OFFICIAL COORDINATION REQUEST FOR NON-ROUTINE OPERATIONS AND MAINTENANCE

COORDINATION TITLE- 14BON01 BI lamprey wetted wall prototype

PROJECT- Bonneville Lock and Dam

Figure 1. Photo of the Bradford Island Fish Ladder showing proposed installation locations A (preferred) and B (if “A” is not acceptable). Lamprey would be guided to the adjacent AWS channel, where two LPS entrance ramps are located.

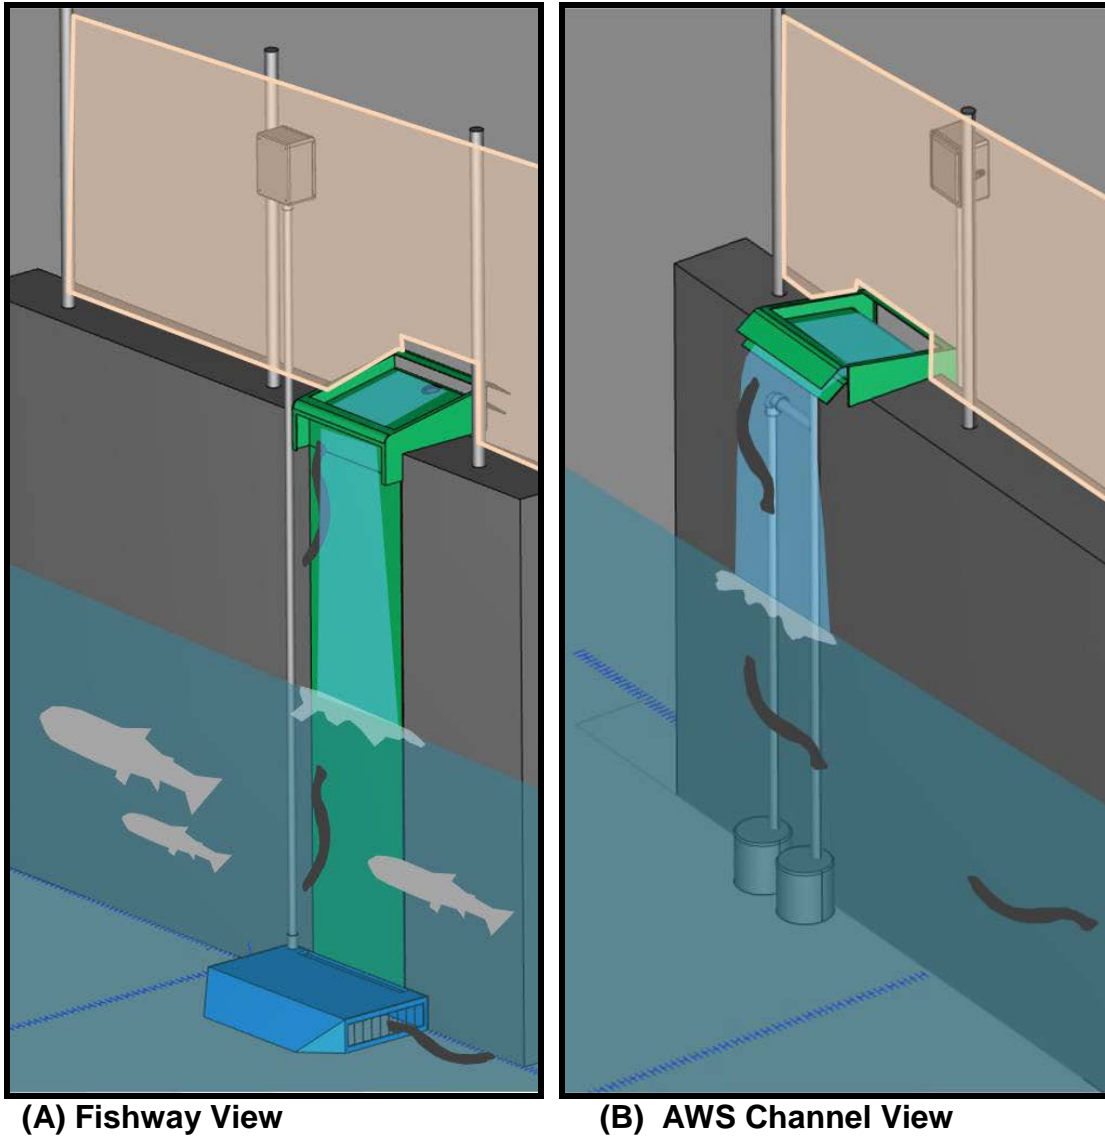
this looks ok, but still have some questions, how much water are we talking about, do not want to cause a false attraction that increases jumping in that area. Also what if any structure will be needed over the fishway, does not look like any. Can give it a tentative of to move forward but a meeting to discuss would be wise. tom

Tammy, I've reviewed this updated MOC. Thanks to those working on this for considering our earlier comments. We support moving forward with this system as indicated. Either location in the ladder is ok, given the changes in the design. The researchers (and the project fisheries personnel) should notify our office if any jumping or unusual delay behavior of adult salmon is noted. I hope it works. Thanks, Gary
